1984 Corvette: Recall: Rear Axle Differential Cross Shaft Retention

Subject: REAR AXLE DIFFERENTIAL CROSS SHAFT RETENTION

Model and Year: 1984 CHEVROLET CORVETTE MODELS

Bulletin Number: 84-C-25 - (09/20/1985)

FIGURE 1

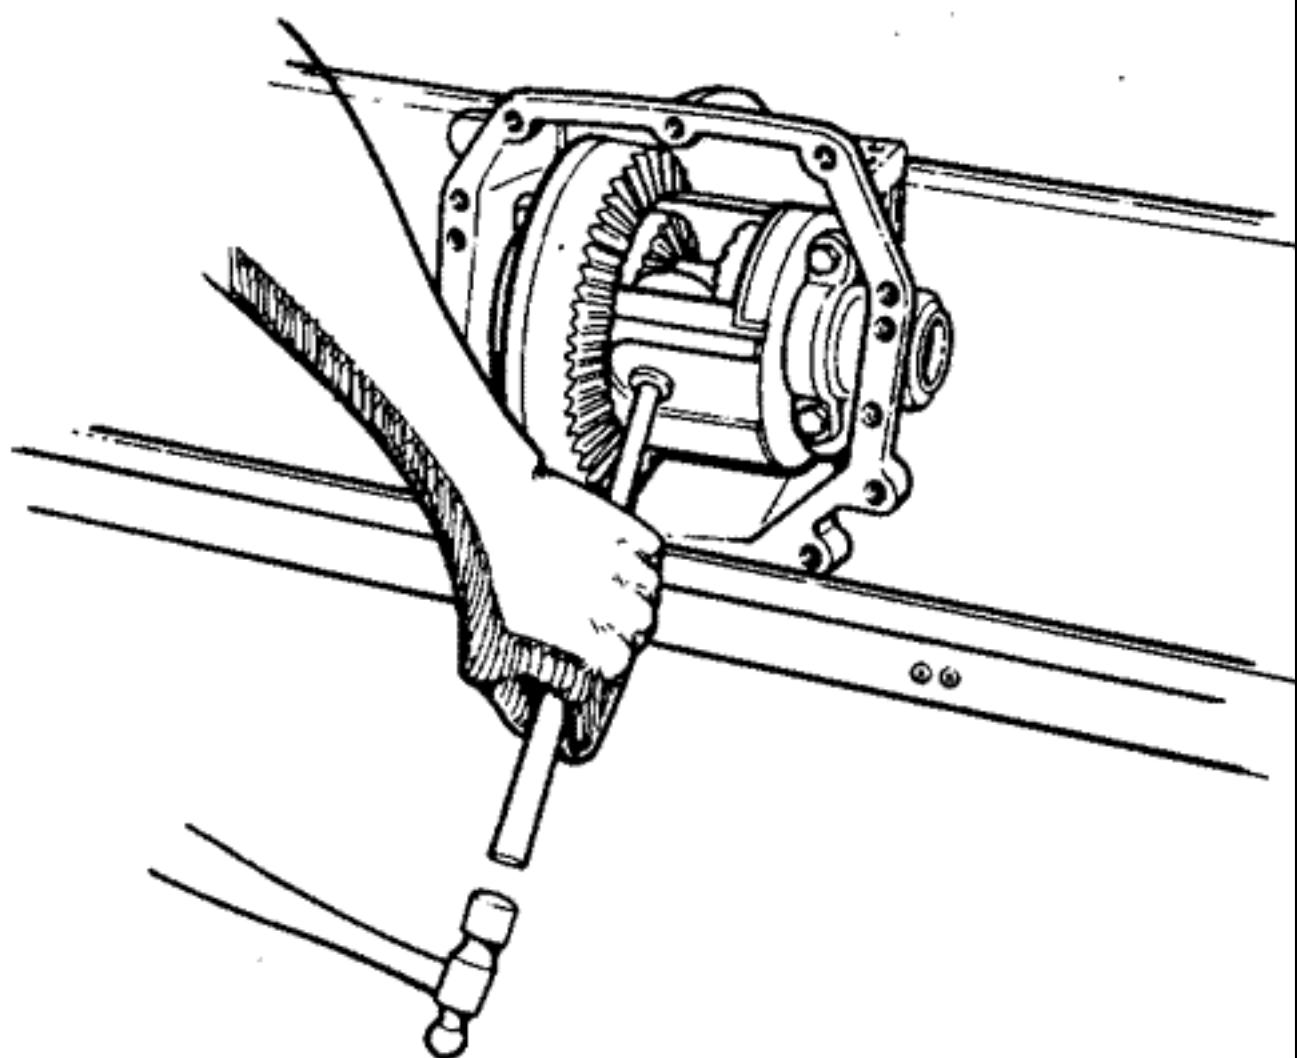
5. Rotate case assembly to position illustrated in Figure 1. With appropriate size drift and small mallet, lightly tap on cross shaft to determine if movement of shaft can be achieved.

FIGURE 2

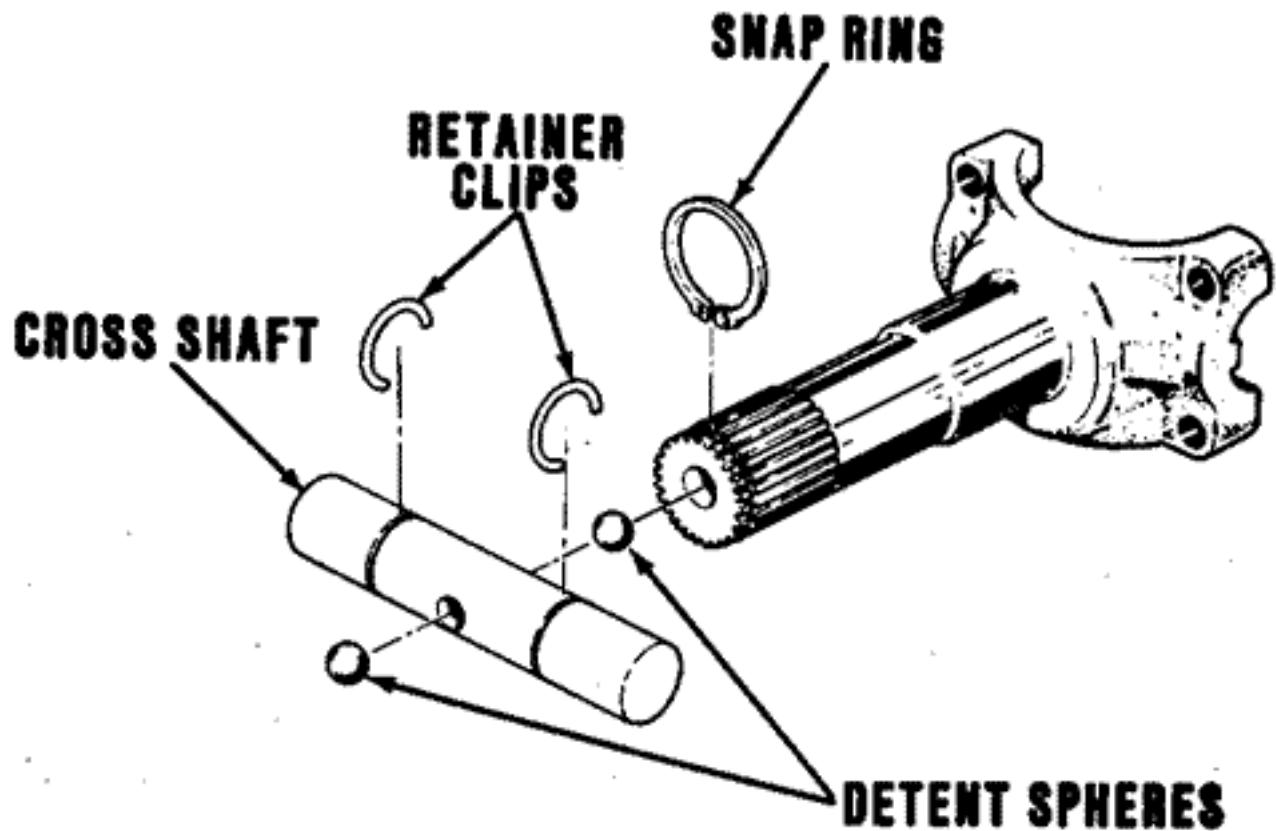
Tap cross shaft inboard approximately 1 1/4 inches and rotate case 180 DEG. Utilizing vise grips and a back and forth motion, remove shaft. Install new cross shaft insuring detents in the shaft are positioned properly to accept spheres (balls) to be installed, between shaft and output yokes as illustrated in Figure 2.

Remove case assembly from carrier following appropriate procedure in 1985 Corvette Shop Manual. Press existing cross shaft out of case and install new cross shaft insuring detents in the shaft are positioned properly to accept spheres (balls) to be installed between shaft and output yokes as illustrated in

Figure 2. Reinstall case assembly following appropriate 1985 Shop Manual procedure.
